A63 Castle Street Improvement, Hull

Scheme Number: TR010016

Environmental Statement Volume 1 Addendum 2
Yorkshire Water Drainage Network

Figure 1: Location of previous proposed long rising main route and outfalls and new proposed short rising route

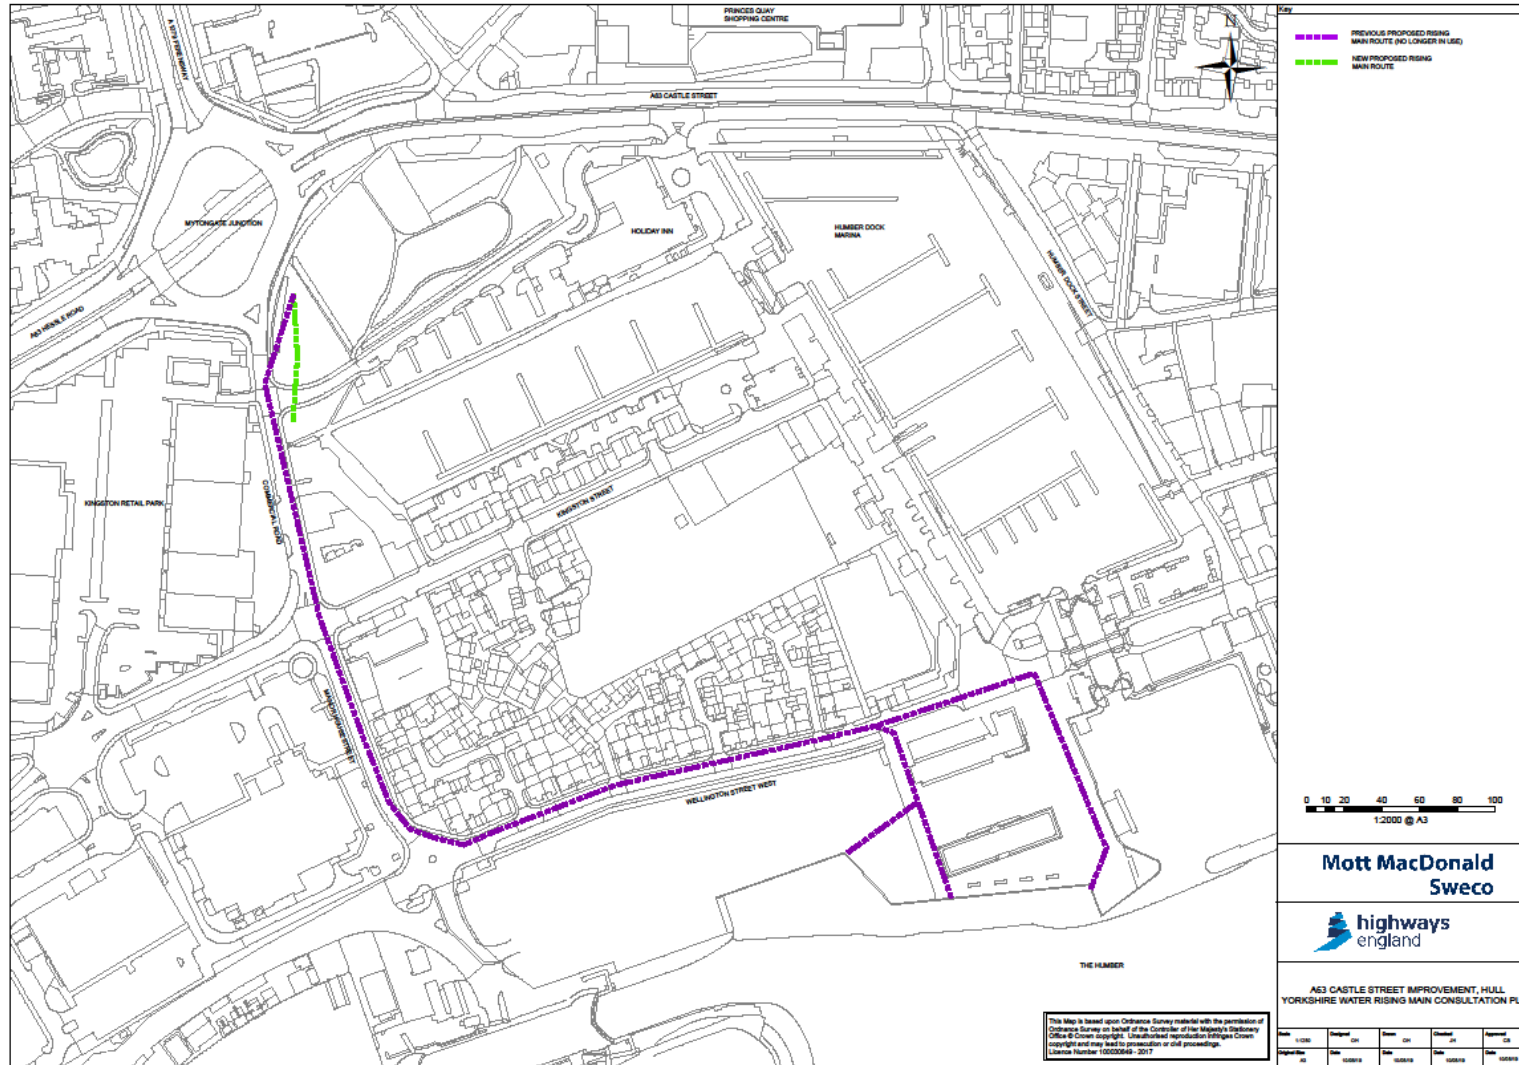
1.2.2 The alternative drainage option to usage of the YW network was to direct the discharge of surface water from the proposed underpass at Mytongate Junction, via a new long rising main to one of three outfall locations into the Humber as shown on Figure 1. The use of existing rock armour at the proposed outfall locations was proposed to prevent the discharge from scouring the river bed and creating silt plumes that could be detrimental to estuarine habitats and species.

- The long rising main route to the outfall - down Commercial Road, Manor House Street and Wellington Street West - can be removed
- A short rising main route from the pumping station across the Holiday Inn access road to a proposed manhole in the land adjacent to Commercial Road – is now required as shown on Figure 1.
- All three proposed outfall locations – can be removed

- The oil interceptors within the pumping station would no longer be required and therefore can be removed
